Eyre Peninsula Roadside Vegetation Management Plan
Comments on Final Draft

Organisation: Nature Conservation Society of South Australia (NCSSA)

Roadside Marker System showing location of markers in relation to Roadside Significant Site and roadway”

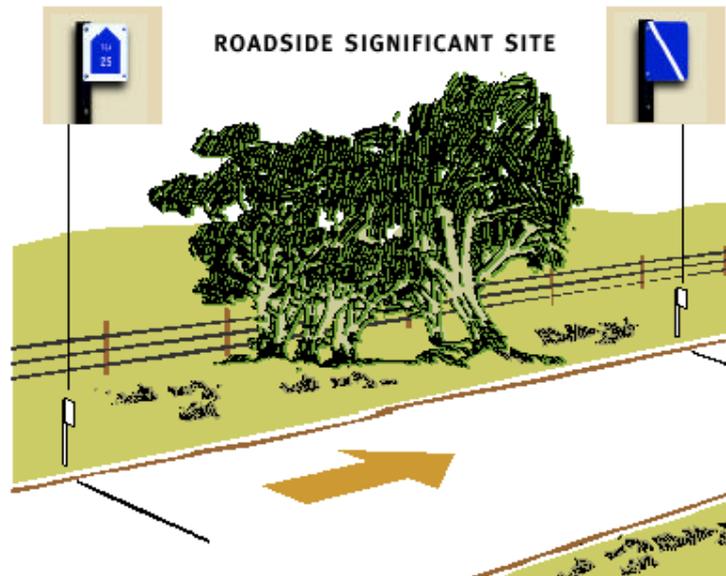
We strongly recommend that the plan acknowledge that the RSSD is supported by a roadside marker system that is intended to be a discreet form of signage to assist rail and road authorities, utilities, council staff and contractors in the recognition of significant sites that are particularly vulnerable to disturbance or damage.

We also recommend that the plan provide a description of the roadside markers as outlined below and a diagram showing their placement in relation to the RSS:
